VDI 2230-1:2014

Mistakes, Comments, Improvement Suggestions

by Fritz Ruoss
HEXAGON Industriesoftware GmbH
Fritz.Ruoss@hexagon.de

Pg.99: Equation (202)

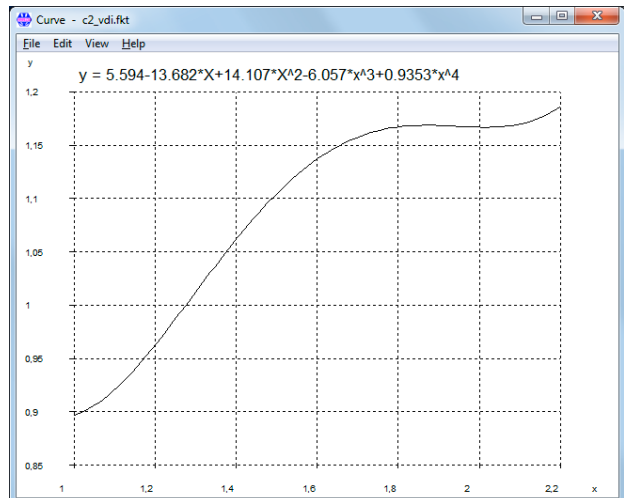
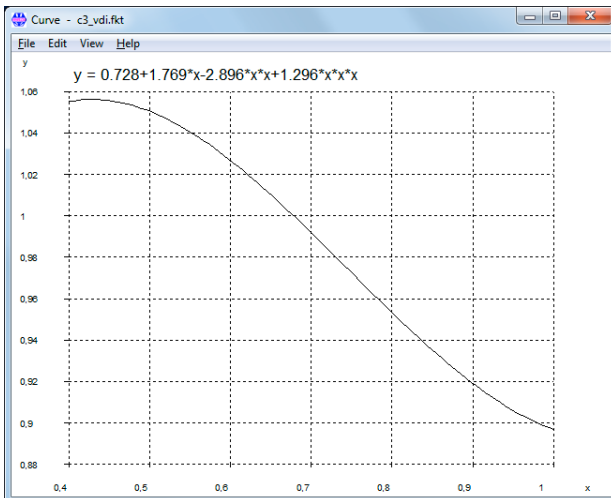
$$C3 = 0.728 + 1.769 RS - 2.896 RS^2 + 1.296 RS^3$$

Function has a maximum at 0.429, not at 0.4. And a minimum at RS=1.061

Scope for RS should be 0.43 .. 1

And for RS <= 0.43: C3=1.055 (not RS=0.4).

Pg. 143: Beispiel B3:

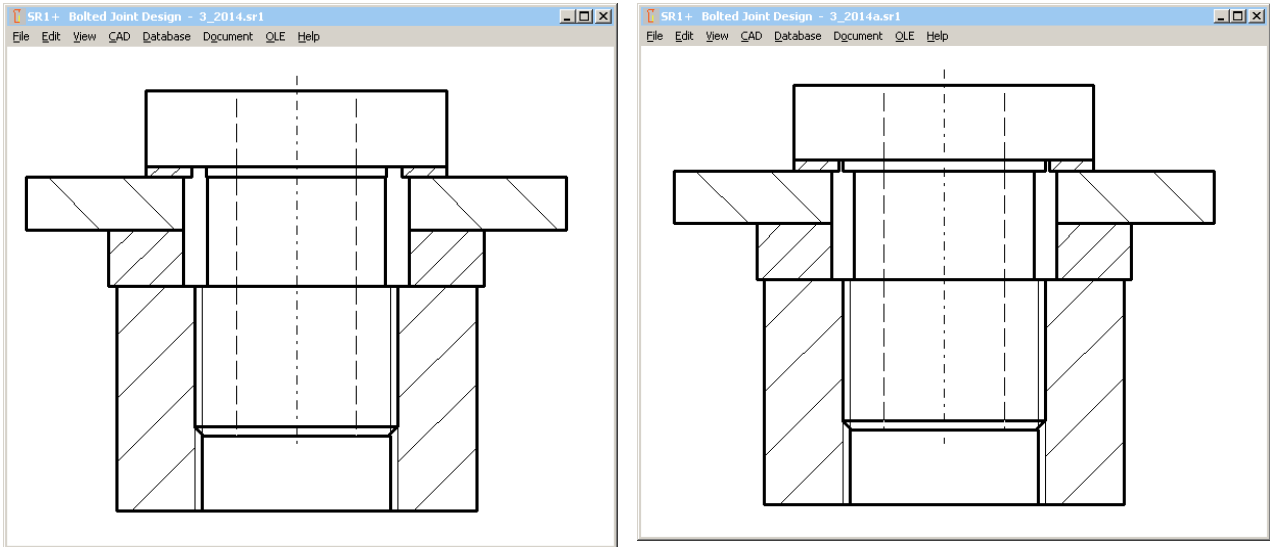
Drawing: Minimum bolt diameter should be d_0 . But in the drawing, minimum bolt diameter is smaller than d_0 . Or the drawing is correct, and error is in dimensioning of d_0 . I assume that d_0 is minimum external bolt diameter, and the first section of the bolt (dimensioned with d_0) is 27 mm.

Pg. 149: Example B4:

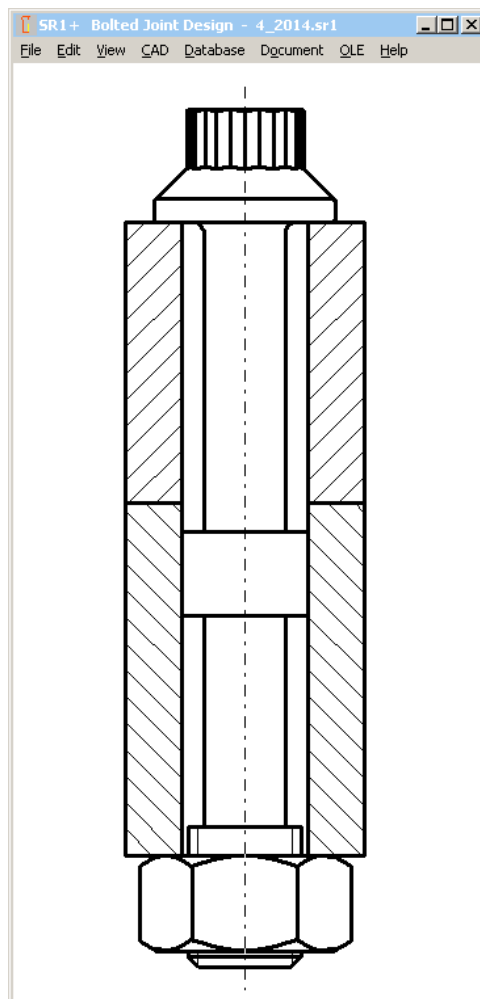
Faulty design: fitting surface of the bolt does not meet interface between connecting rod and connecting rod bearing cap. Bolt must be assembled upside down (bolt head at connecting rod side) or bolt dimensions have to be modified.

Apart from that, I would recommend a fine thread for this application.

Pg. 152: Example B4: R2

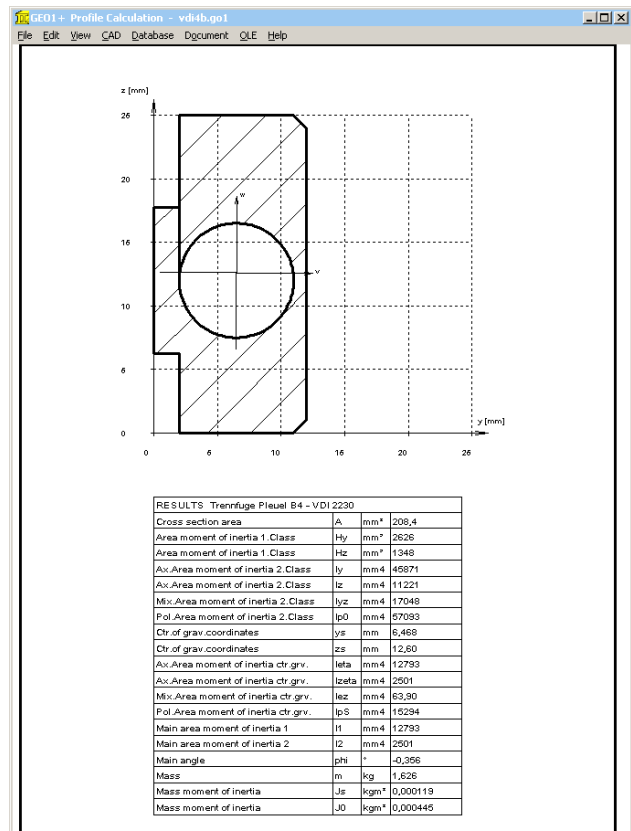
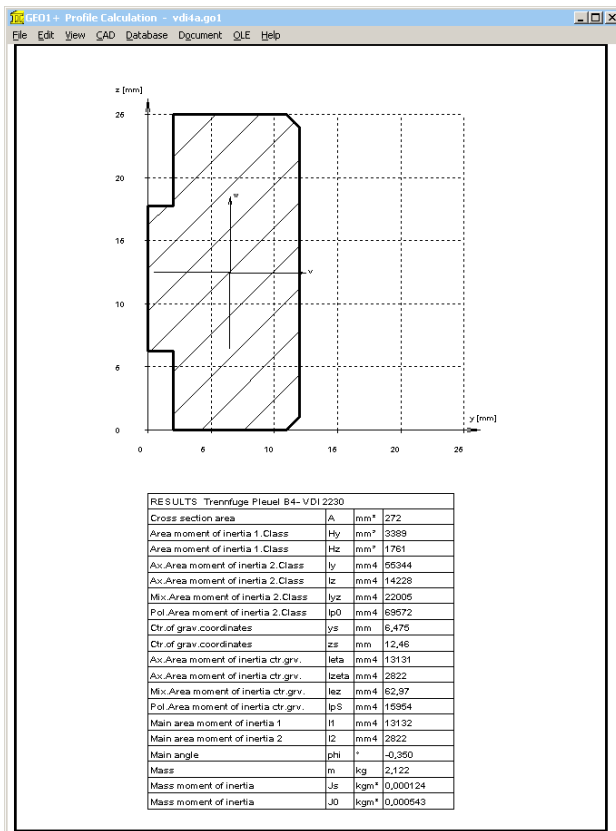
The determination of the of the total area produces $A_{ges} = 12 \cdot 25 = 300 \text{ mm}^2$, not 272 mm^2 .

Or was it calculated with the precise interface section? If yes, these values also should be used for IBT.

But $IBT = b \cdot cT^3 = 3600 \text{ mm}^4$

Calculated by means of GEO1+ with $A_{ges}=272 \text{ mm}^2$: $IBT = 2822 \text{ mm}^4$

Pg. 162: Example B5:

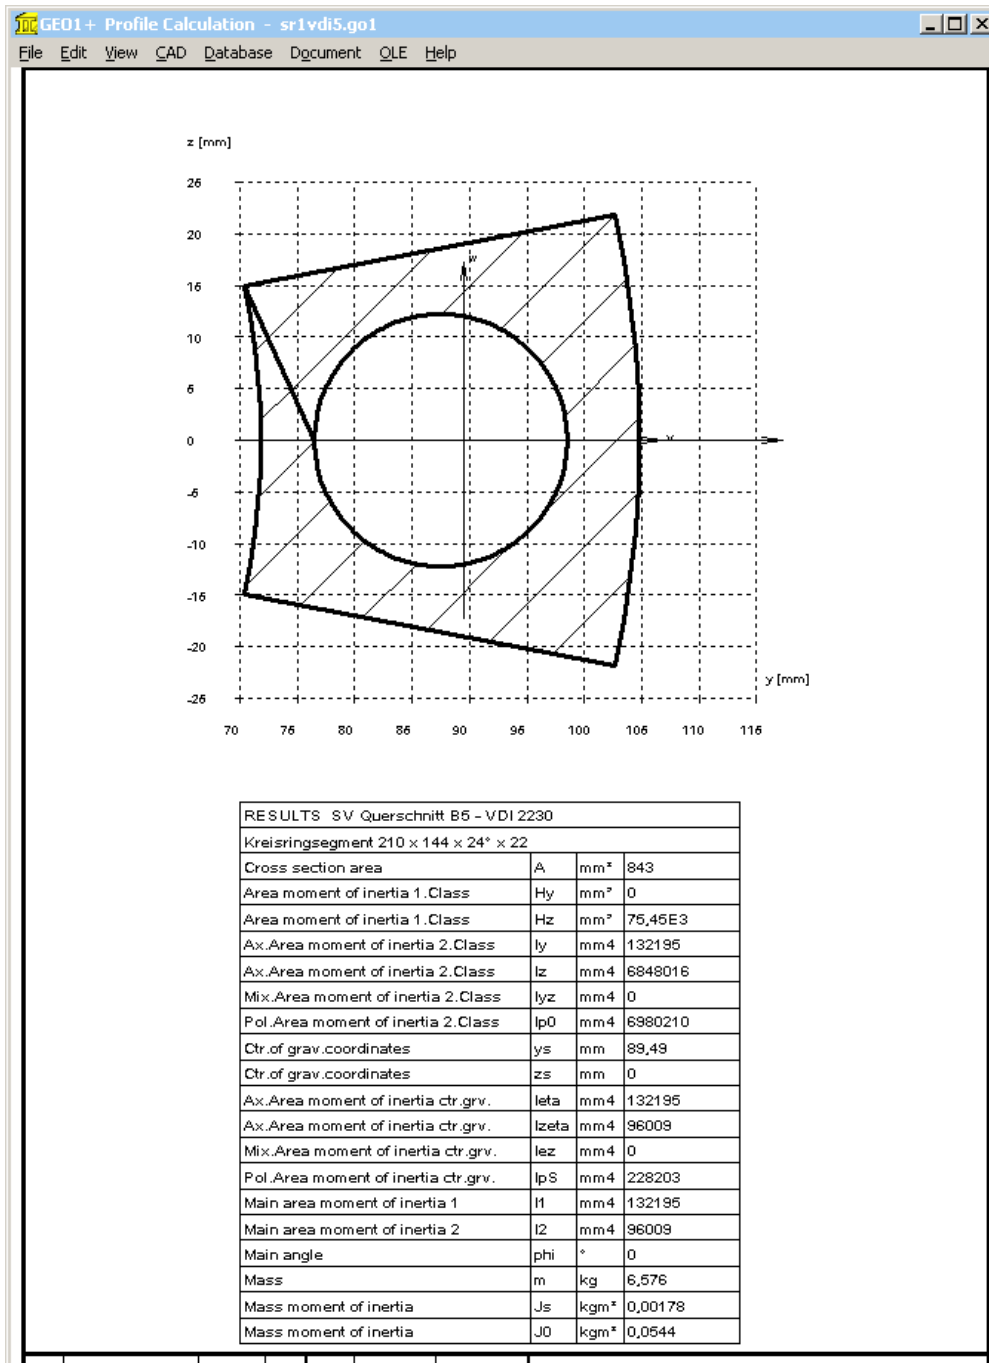
Recalculation: $ssym$ is $+1.98$ mm, and not -1.7 mm. Even in figure B7, $ssym$ is positive. "Check for the sign rule according to table 4" corresponds to case I, and not to case III. $ssym$ is the distance between center of gravity axis and bolt axis. GEO1+ software may be used to calculate center of gravity and $ssym$.

With coordinates of interface area are $r_i=72$ mm, $r_e=105$ mm, $\alpha = 24^\circ$, $r_s=87.5$ mm and $dh=22$ mm, GEO1+ calculates $y_s=89.48$ mm. Thus $ssym = y_s - r_s = 89.48 - 87.5 = 1.98$ mm, $u = y_s - r_i = 89.48 - 72 = 17.48$ mm, and $v = r_e - y_s = 15.48$ mm. Area moment of inertia at w axis is $Izeta = IBT = 95985$ mm⁴.
